**HARTZELL PROPELLER INC.**

**MANUAL REVISION TRANSMITTAL**  
**Manual 143A (61-10-43)**  
**Four Blade Lightweight Turbine Propeller**  
**Overhaul Manual**

**REVISION 27 dated December 2023**

HC-E4A-3A: Propeller Parts  
Figure 10-16

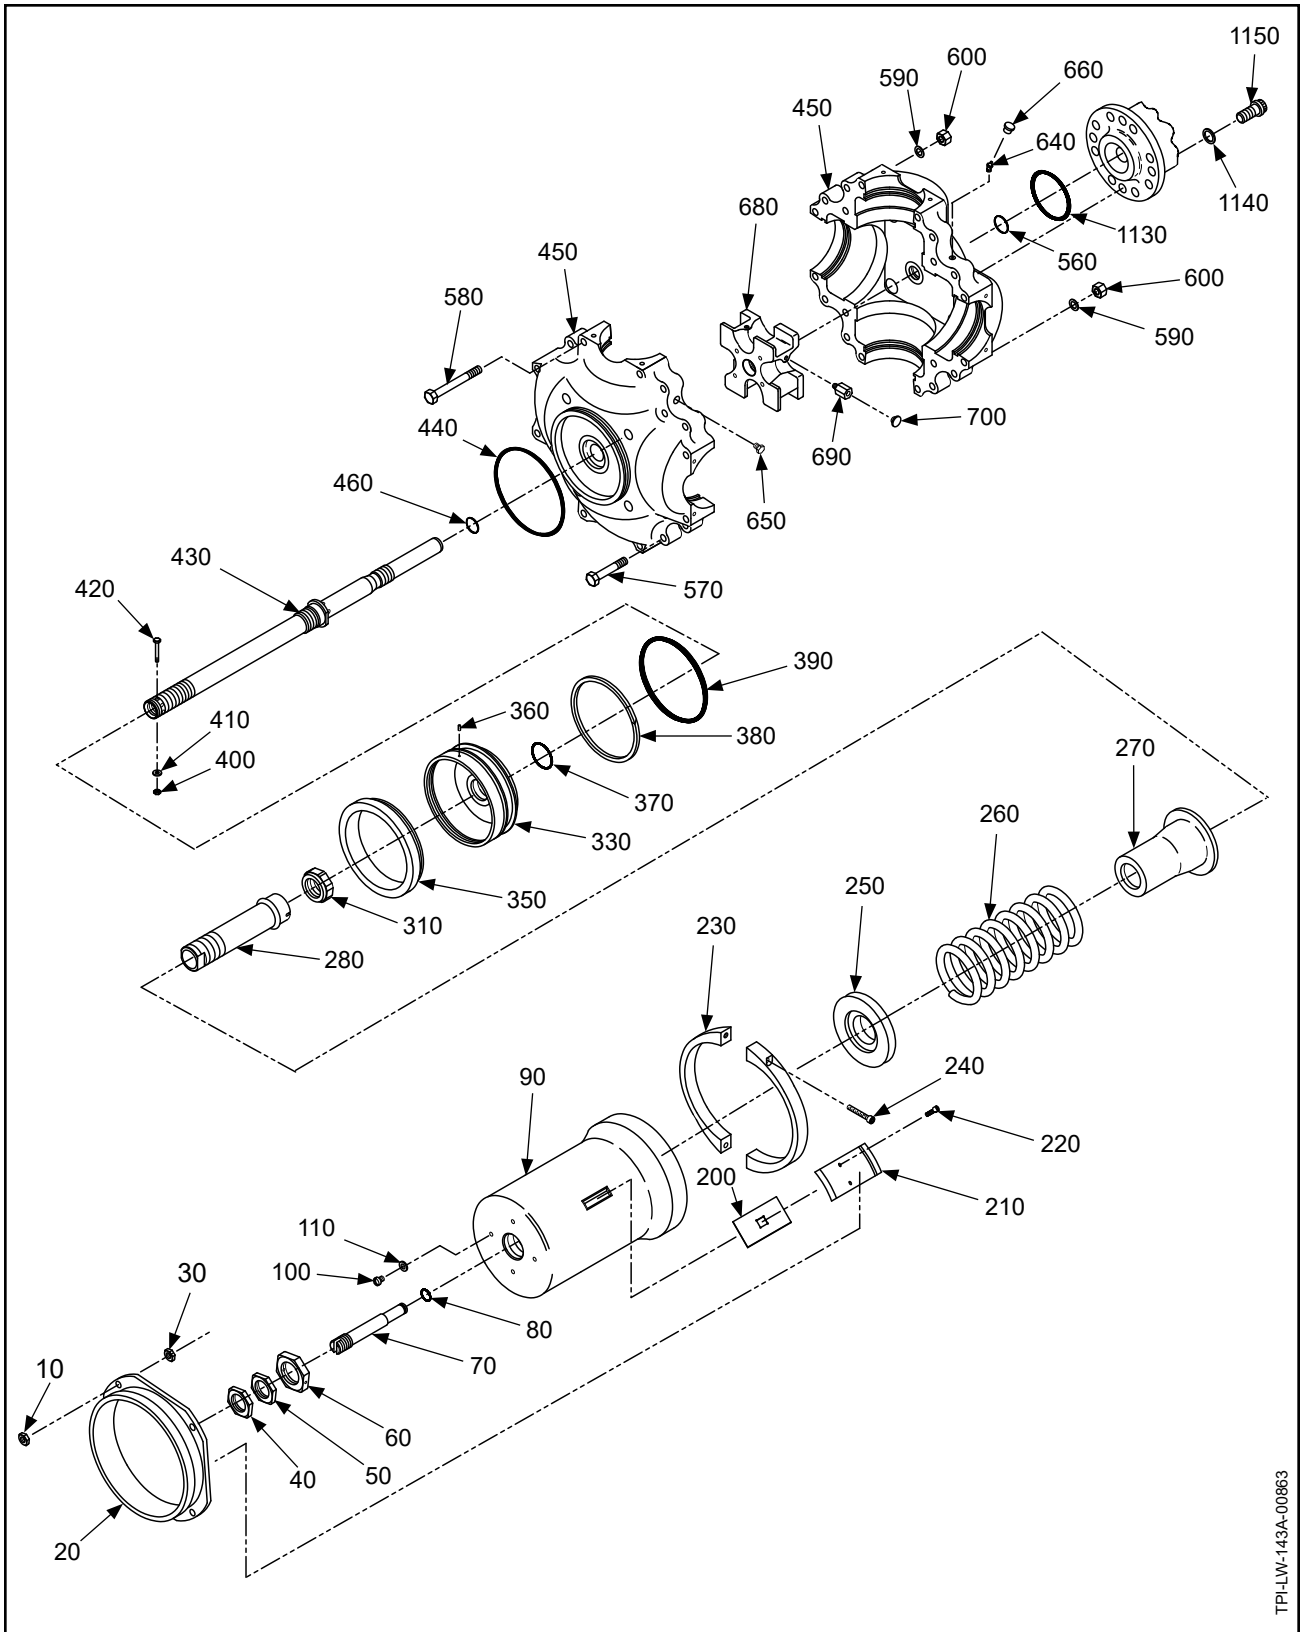
- Revised Figure 10-13, "HC-D4N-3Q, -3T: Propeller Parts"
  - Revised Figure 10-16, "HC-E4A-3A: Propeller Parts"
  - Revised the illustrated parts list for propeller model HC-E4A-3A

HC-E4A-3I: Propeller Parts  
Figure 10-22

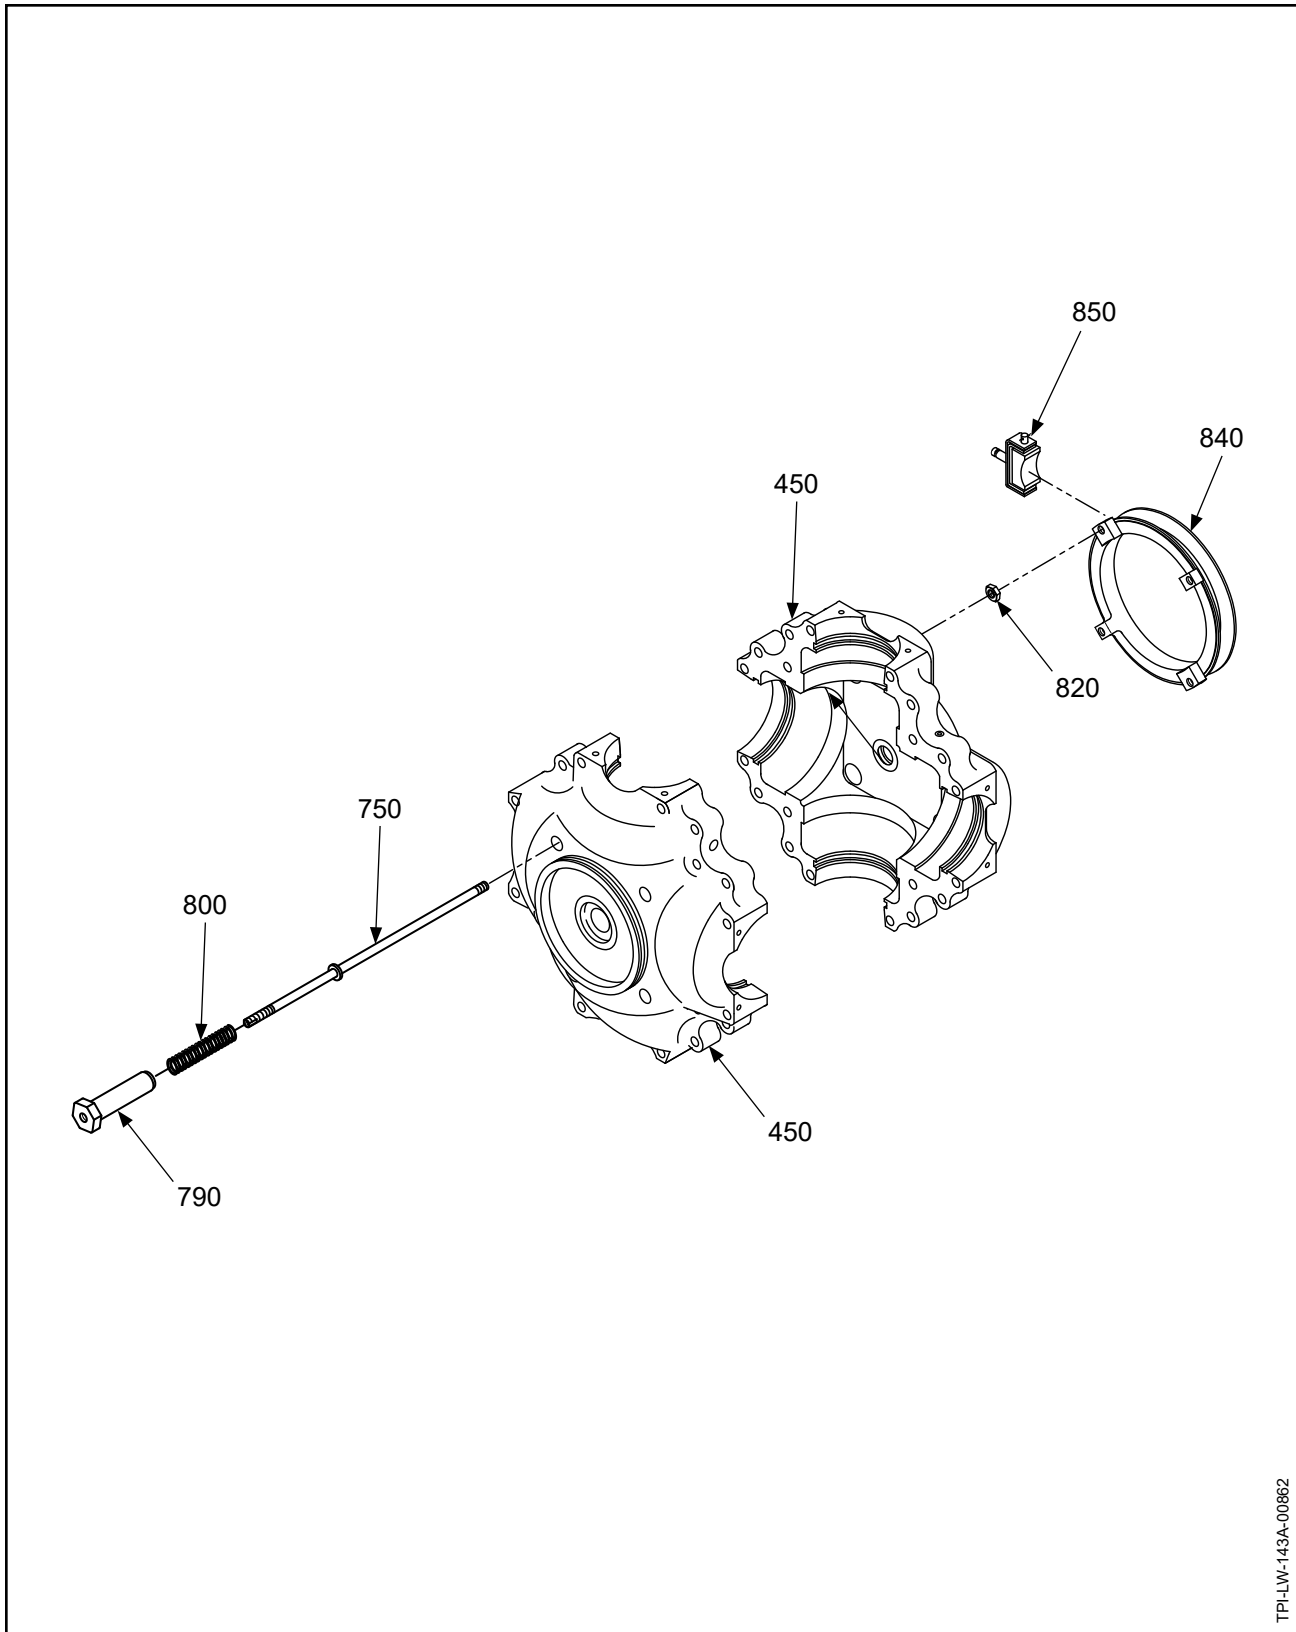
- Revised Figure 10-19, "HC-E4A-3D: Propeller Parts"
  - Revised the illustrated parts list for propeller model HC-E4A-3D
  - Revised Figure 10-22, "HC-E4A-3I: Propeller Parts"

HC-E4A-3M: Propeller Parts  
Figure 10-28

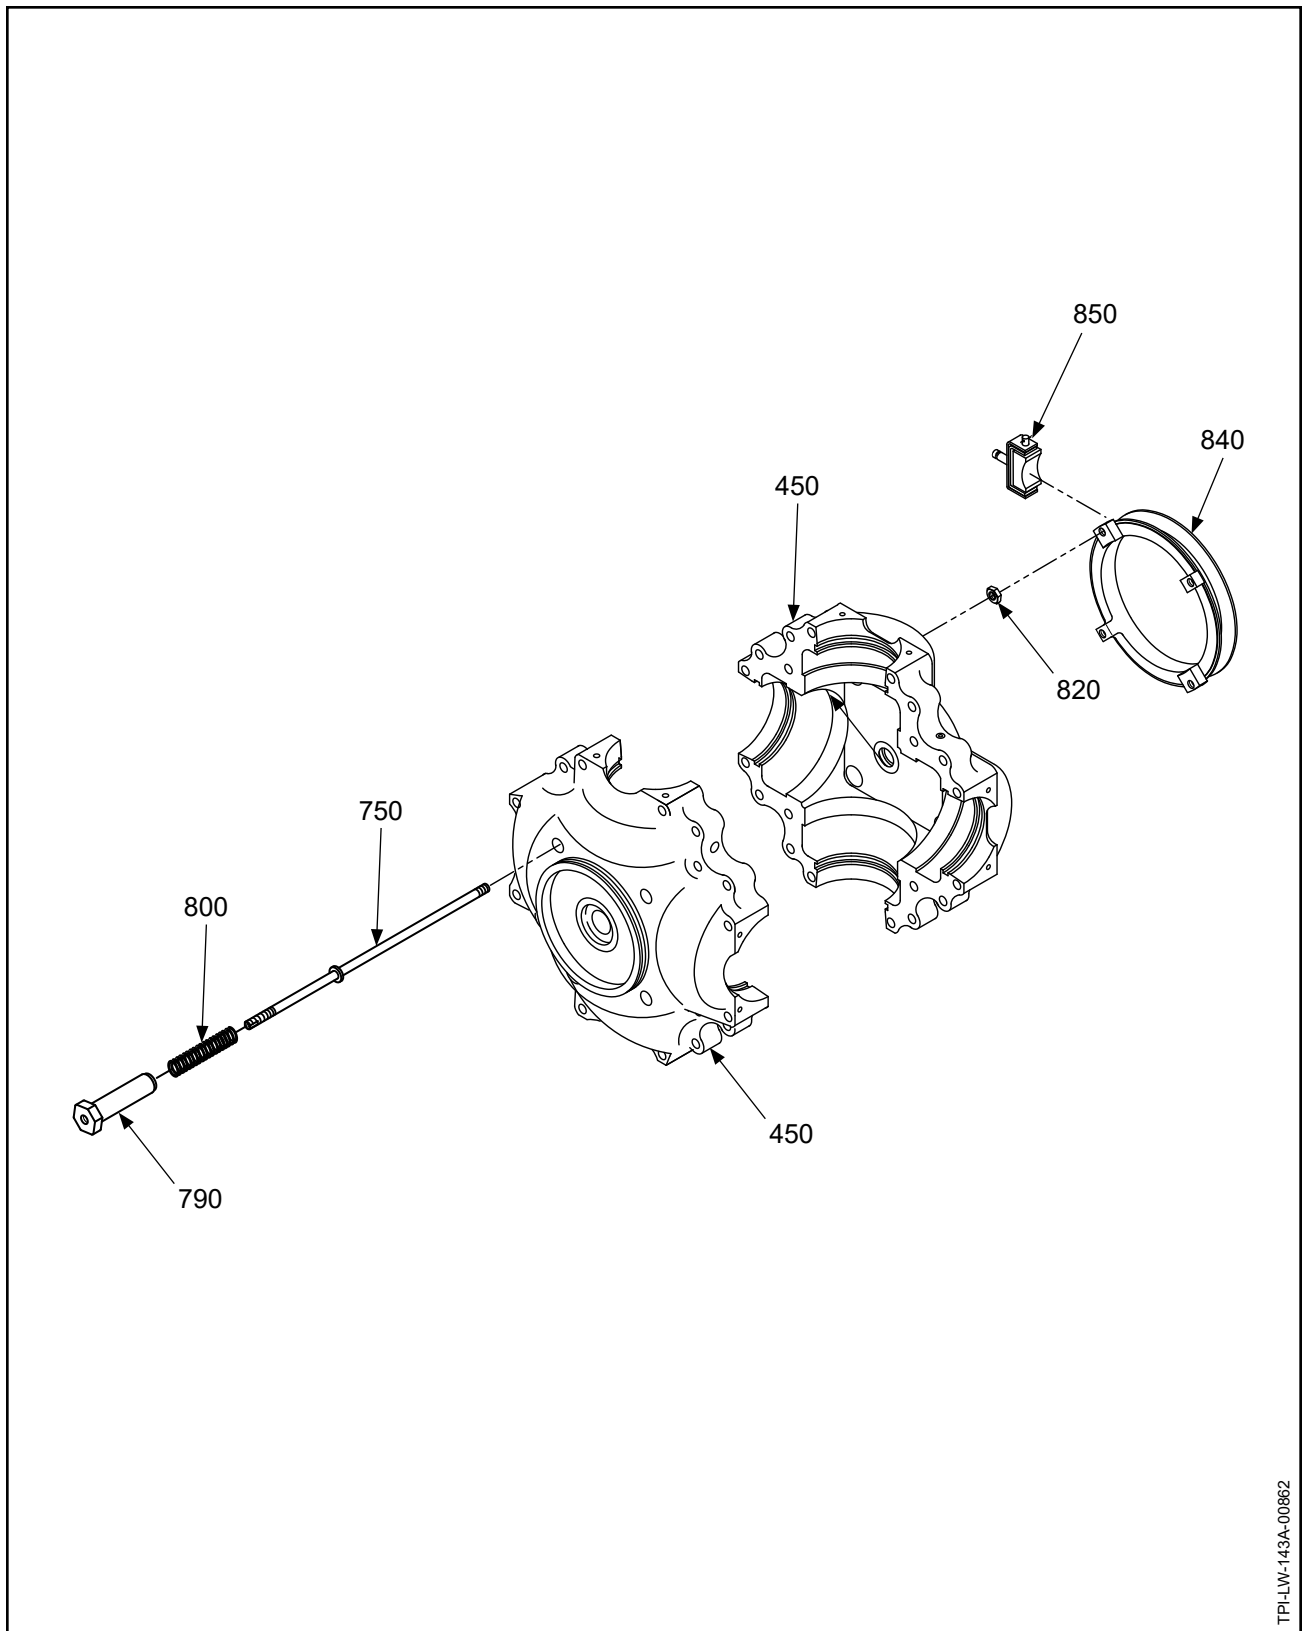
- Revised Figure 10-28, "HC-E4A-3M: Propeller Parts"
  - Revised the illustrated parts list for propeller model HC-E4A-3M
  - Added the illustrated parts list and figures for propeller model HC-E4N-3KU
